## **ZIMLICH'S SECOND ADDITION, RESUBDIVISION OF LOTS 2, 3 AND 6, BLOCK 2**

APPLICATION NUMBER 9 DATE September 6, 2018  
 APPLICANT Zimlich's Subdivision, Second Addition, Resubdivision of Lots 2, 3, and 6, Block 2  
 REQUEST Subdivision

# DETAIL SITE PLAN

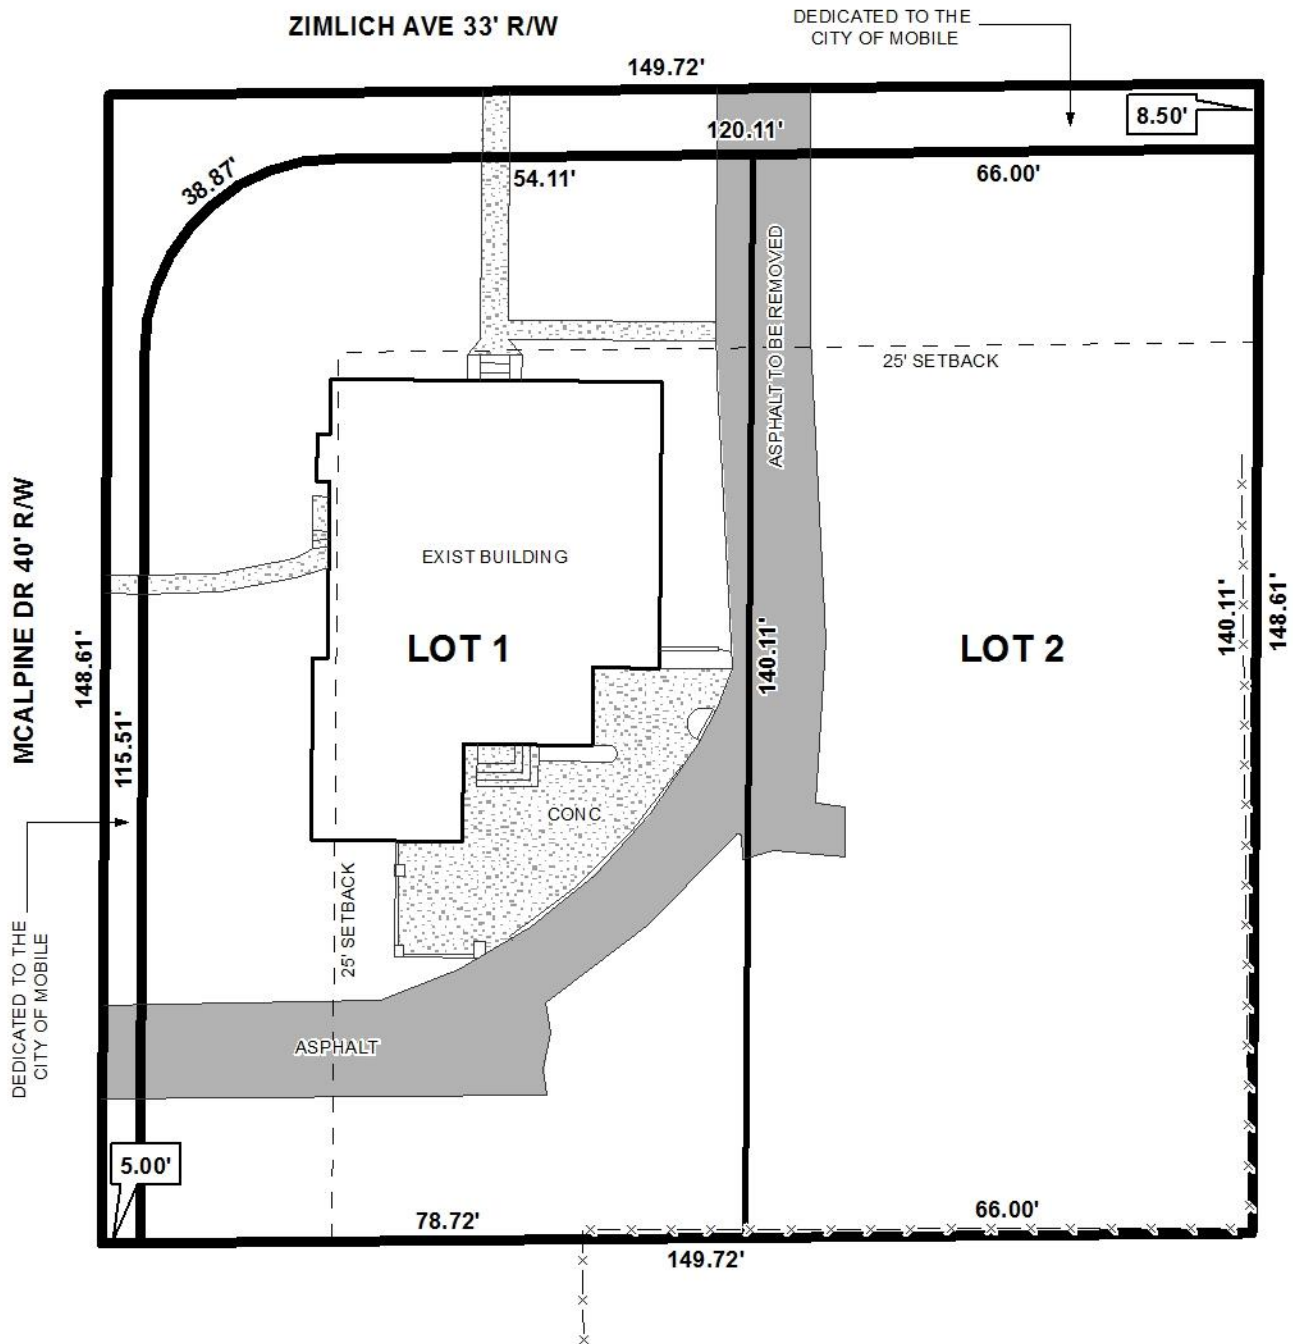
The proposed lots front Zimlich Avenue and McAlpine Drive, both minor streets, requiring 50' right-of-way widths. The preliminary plat illustrates a 40' right-of-way width to McAlpine Drive and a 33' right-of-way width to Zimlich Avenue. The preliminary plat illustrates dedication to provide 25' from the centerline of McAlpine Drive and Zimlich Avenue, and corner radius dedication per Section V.D.6. of the Subdivision Regulations and this should be retained on the Final Plat.

A 25-foot minimum building setback line is depicted on the preliminary plat along McAlpine Drive and Zimlich Avenue. It should be noted that the existing dwelling located on the proposed Lot 1 will encroach into the minimum building setback along McAlpine Drive after right-of-way dedication.

The proposed lots exceed the 7,200 square foot minimum lot size requirements for lots served by public water and sanitary sewer systems. The preliminary plat provides the lot size in square feet and acres. If approved, provision of the lot size information in square feet and acres will be required on the Final Plat.

As a means of access management, a note should be placed on the Final Plat, if approved, stating that each lot is limited to one curb cut, with size, location and design to be approved by Traffic Engineering and conform to AASHTO standards.

- 1) Retention of the dedication to provide 25' from the centerline of McAlpine Drive and Zimlich Avenue;
- 2) Retention of the corner radius dedication per Section V.D.6. of the Subdivision Regulations;

- 3) Retention of the 25' minimum building setback line along both street frontages, adjusted for dedication;
- 4) Retention of lot size information in both square feet and acres, adjusted for dedication;

- 5) Placement of a note on the Final Plat stating that each lot is limited to one curb cut, with the size, design and location to be approved by Traffic Engineering and conform to AASHTO standards;
